Administrative Approval Action

AA # 3919 / SR-86-18, Wakefield Professional Plaza
Transaction# 568980

REQUEST: Development of two lots to be recombined into a 3.19 acre tract zoned CX-3-PK and in a UWPOD Overlay into a 36,360 square foot three-story medical office building with on-site parking.

Design Adjustment Sketch

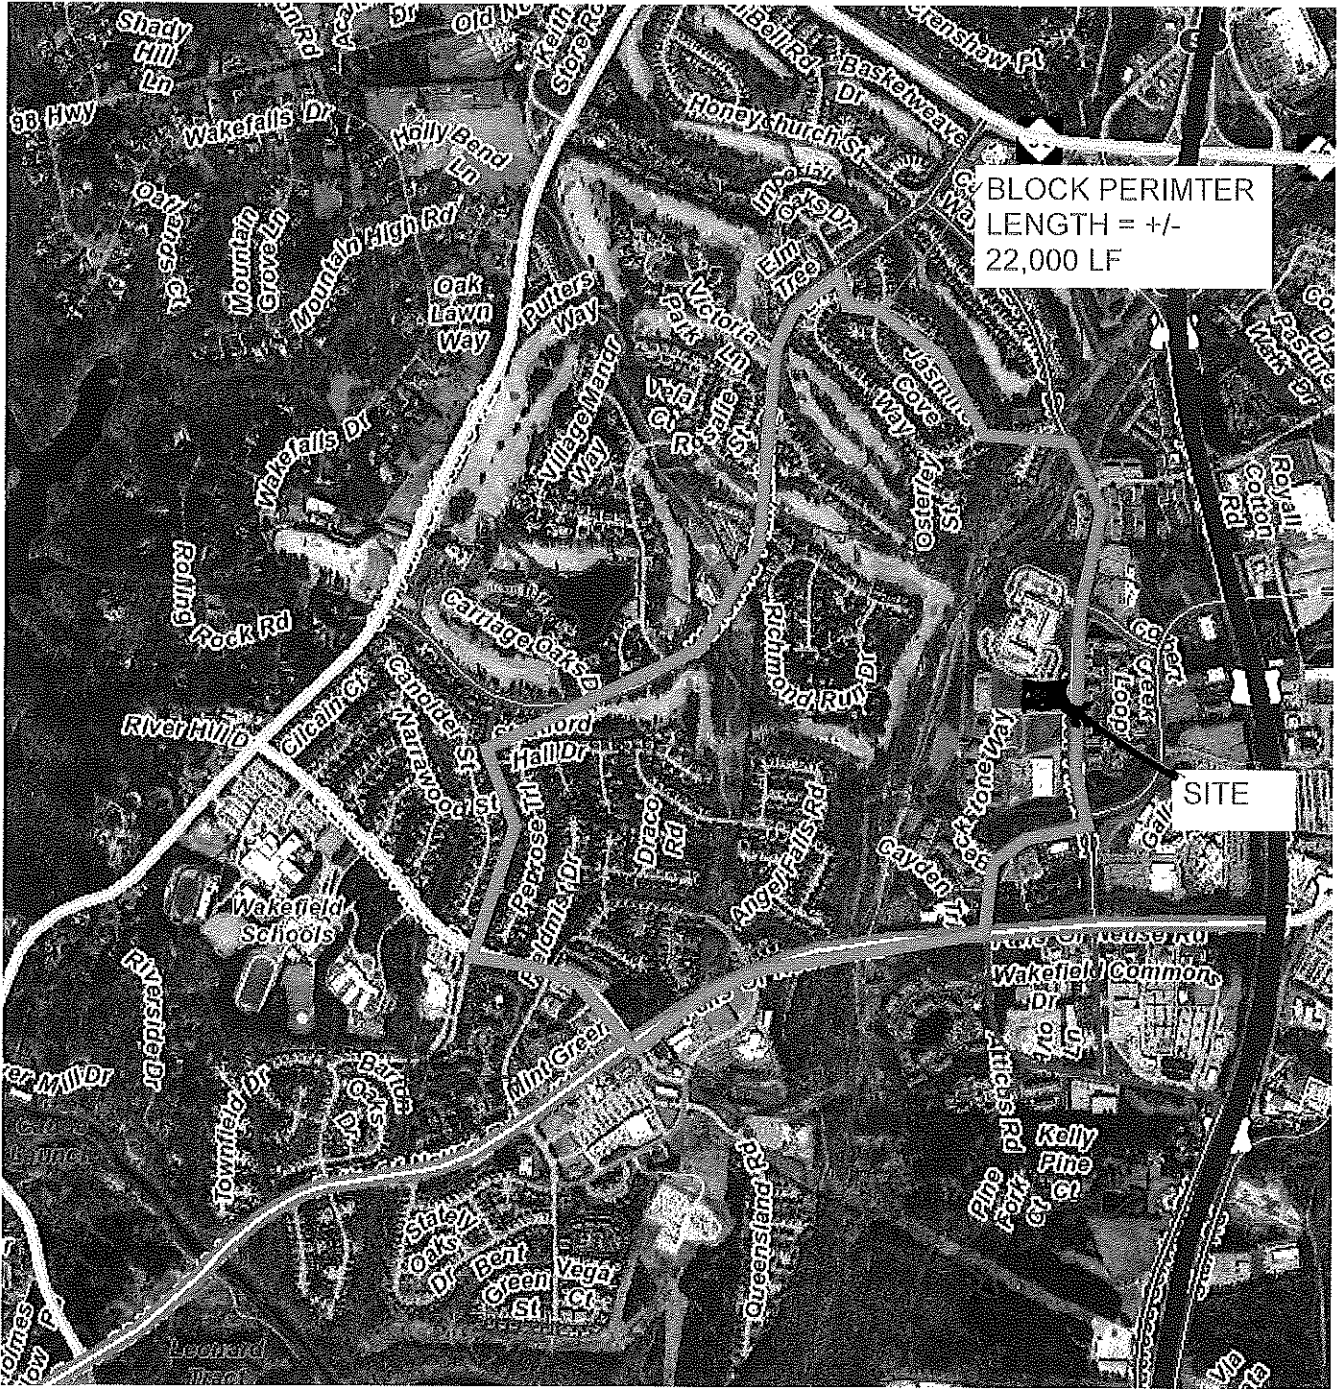
The zoning for this property is CX-3 which requires a maximum block perimeter of 3,000'. This plan is being constructed with access coming from existing Ingleside Place. This street provides public access to the cul-de-sac bulb which is 480' in length and continues to the terminus as privately owned by the north and south parcels west adjacent to Ingleside Place. Wakefield Plantation Tournament Players Club -Golf Course exists west of Ingleside Place thereby preventing a connection that would reduce the current block perimeter.

The existing 5' sidewalk along Forest Pines Drive and Ingeside Place will remain in place to be consistent with adjacent development. A fee-in-lieu for 1' sidewalk will be required to supplement the existing sidewalk to meet the current 6' sidewalk width requirement per the UDO.

Due to existing primary tree conservation area adjacent to Forest Pines Drive and the determination that Ingeside Place will not be widened in the future, the 5' utility placement easement was not required.

The proposed development is planning to develop an outparcel of a previously developed site on Ingleside Place #1 - 8.3 - The block perimeter length for this lot exceeds the allowable 3000 LF. #2 - 8.5 - Maintain sidewalk 5' width and 3.5' planting strip within right-of-way to match existing 5' sidewalk along Ingleside Dr and adjacent properties. #3 - 8.5 - Exclude 5' general utility easement outside of proposed right-of-way.

The main reason for the exceeding length requirement is due to a large jurisdictional stream that bisects this area of development (Richland Creek).

The two stream crossings north and south of the site are along a secondary arterial (Falls of Neuse Rd) and a Minor Thoroughfare (Forest Pines Drive).

No other crossing would be justified due to stream impacts.
